AEROPRAKT SERVICE BULLETIN

No. SB A32-04

REINFORCEMENT OF THE ROOF PANEL RIVET JOINT AT FRAME No.3 OF A32 AND A32L AIRCRAFT

Fig.1

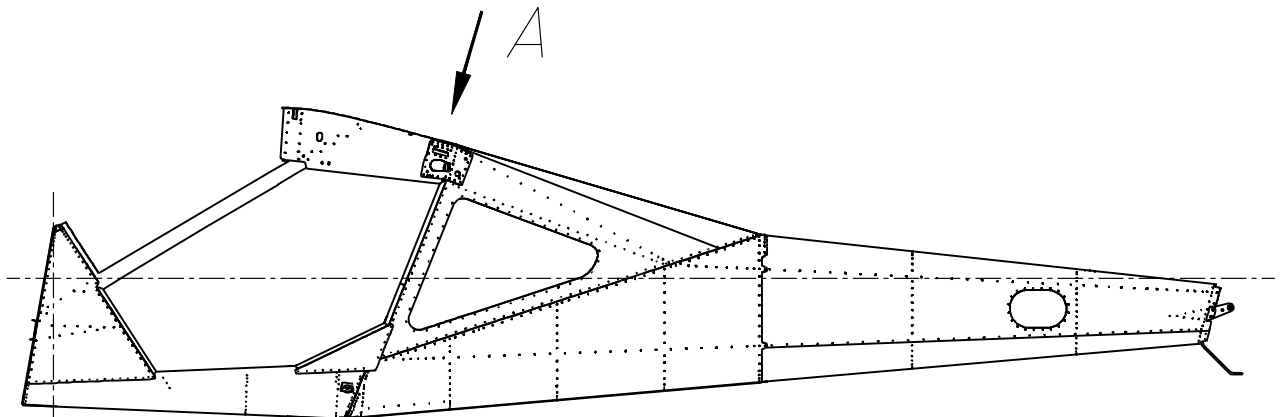
- 3.1) Inspect the rivet joint of the roof panel and frame No.3 (Fig.1, 2, 3), check number of the rivets (intervals between them) and their condition.
- 3.2) If number of the rivets (intervals between them) are as shown in Fig.3 and the rivets are not loosened, this repair work is not needed.
- 3.3) If number of the rivets (intervals between them) are as shown in Fig.2 and the rivets are loosened, this repair work must be accomplished.
 - 3.3.1) Mark and drill with $\varnothing 3.1$ mm drill bit the holes for additional rivets according to Fig.3.
 - 3.3.2) Insert and set the additional $\varnothing 3 \times 8$ rivets.
 - 3.3.3) Undrill the loosened rivets with $\varnothing 3.1$ mm drill bit and install the new $\varnothing 3 \times 8$ rivets.
 - 3.3.4) Paint the rivet heads with color of the airplane.
